RE: Traffic Impact and Parking Study Review #1 – Illinois Properties 26 LLC, 775 North Main Street (NYS Route 45) Office Expansion, Village of New Hempstead, Rockland County, NY

On behalf of the Village of New Hempstead, LaBella Associates DPC (LaBella) has performed a traffic and transportation engineering review of the proposed expansion of an existing office building located at 775 Main Street in the Village of New Hempstead. In conducting this review, the following documents were considered and evaluated:

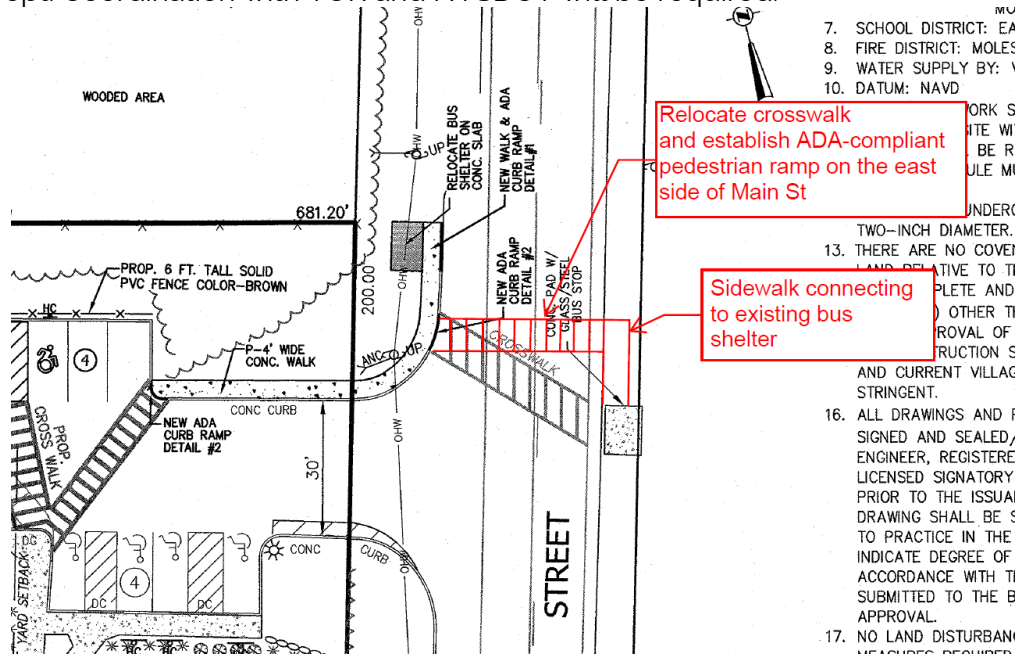
- 1. The applicant should provide an update on the status of the NYSDOT Highway Work Permit process for work on NYS Route 45 (Main Street).
- 2. LaBella recommends that the applicant complete the sidewalk and pedestrian ramp connection for the northbound bus stop on NYS Route 45 and straighten the midblock crosswalk to reduce the overall crossing distance as shown in the below concept. Coordination with TOR and NYSDOT will be required.

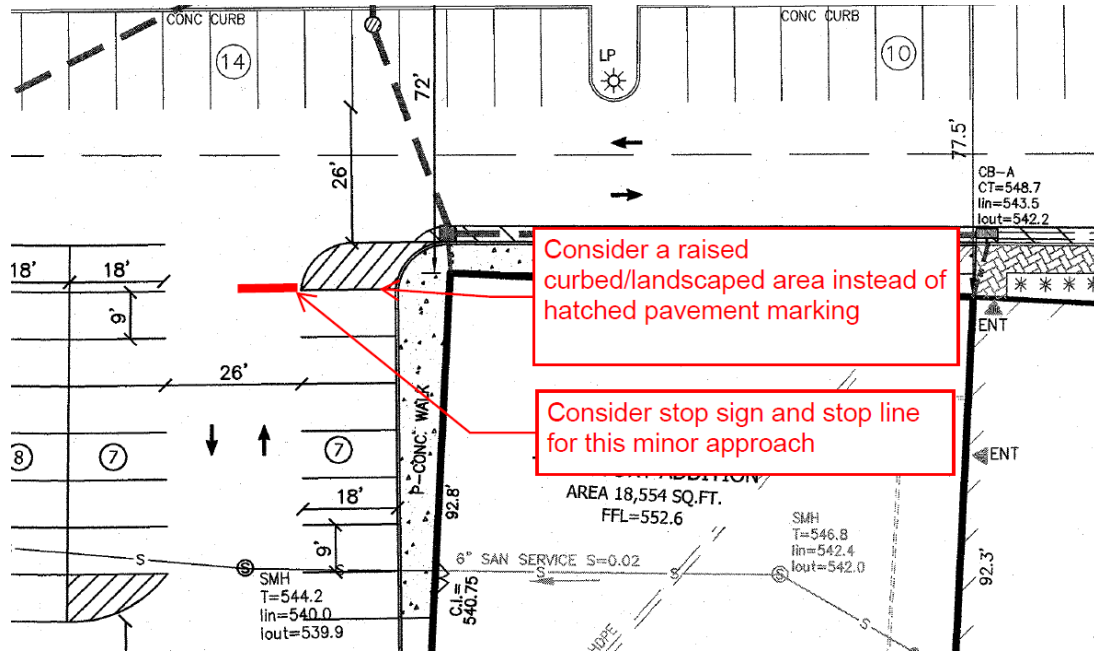
- 3. The proposed expansion may block the sight lines of drivers approaching the internal intersection immediately west of the westerly extent of the future building. Possible applications that can help mitigate these issues are shown in the concept below. This should be examined and addressed by HBA.
